APPLICATION FOR PERMISSION
UNDER SECTION 16 OF
THE TOWN PLANNING ORDINANCE
(CAP. 131)

(S.16 Planning Application No. A/YL-SK/400)

We write to submit further information in response to department comments of the subject application.

Response-to-Comment

Revised FSI Proposal

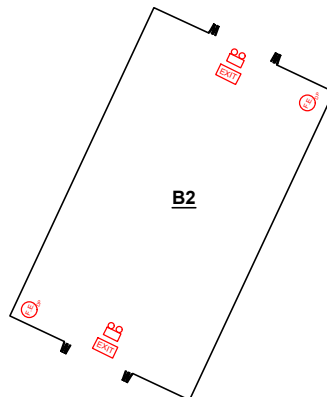
Departmental Comments		Applicant's Responses
1. Comments of the Director of Fire Services (D of FS)		
(a)	Structures on the same site are regarded as adjoining structures if they are less than 1.8 m apart. In this regard, sprinkler system, modified hose reel system, fire alarm system, emergency lighting, directional and exit signs and portable fire extinguishers shall be provided to Structures B1 and B2 as the total floor area exceeds 230 m ² ; and	Kindly note that Structures B1 and B2 are about 5.7 m apart. As such, the floor area of each structure should be considered separately, where no structure has exceeded the total floor area of 230 m ² . Illustrations of the distance between each structure have been added onto the enclosed revised fire service installations (FSI) proposal at Annex 1 .

(b)	The standards and specification of the proposed directional and exit signs shall be revised to 'BS 5266-1:2016 and the FSD Circular Letter No. 5/2008'.	Noted. Please refer to the revised FSI proposal at Annex 1 .

Revised Layout Plan and Swept Path Analysis

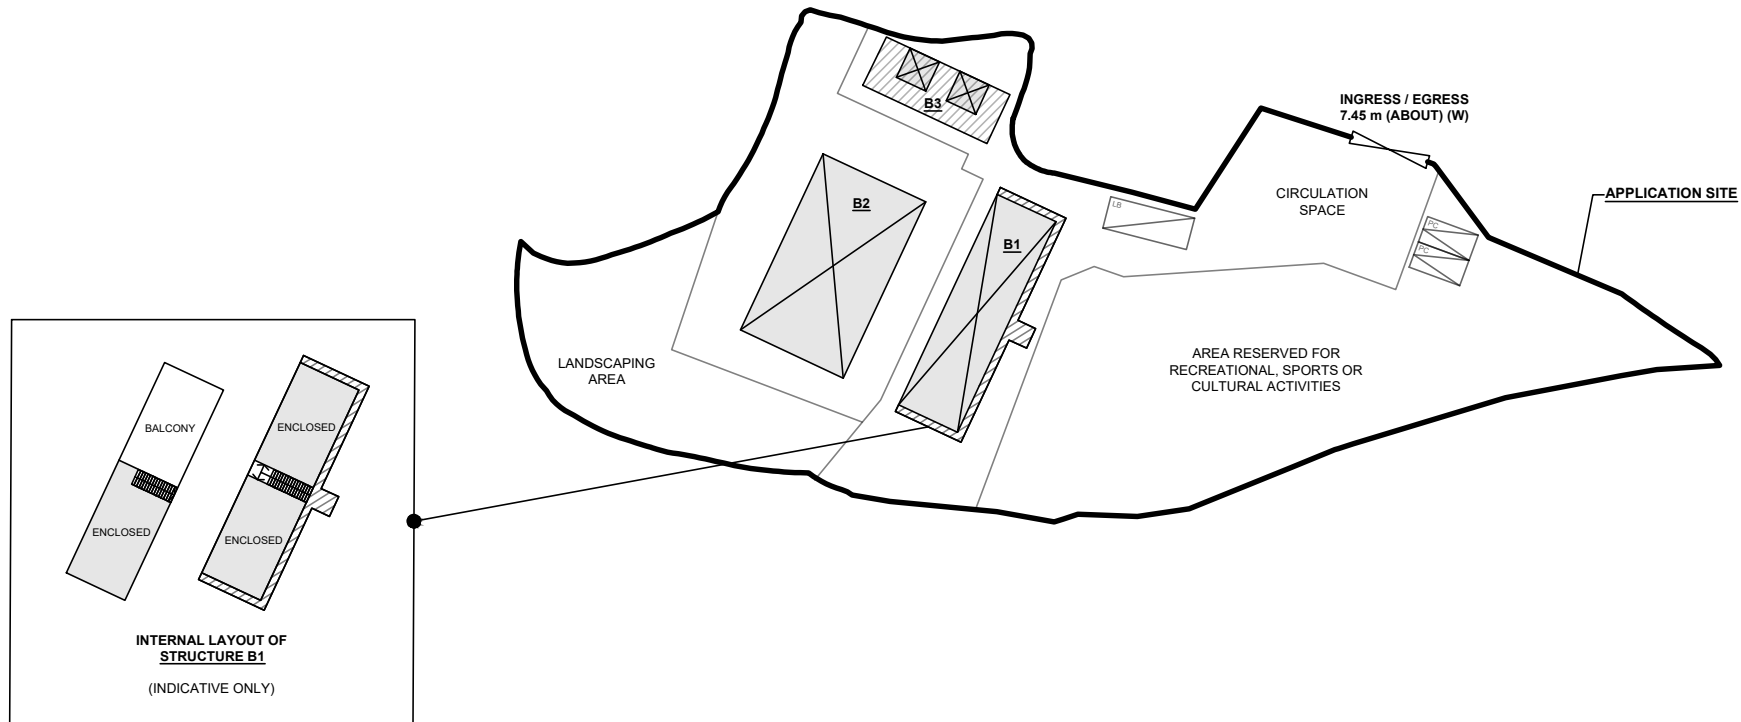
- (iii) In order to reflect the revised dimension in the run-in/out proposal, the applicant has submitted the revised layout plan and swept path analysis to rectify the width of the ingress/egress of the application site. The revised plans are enclosed at **Annex 4**.
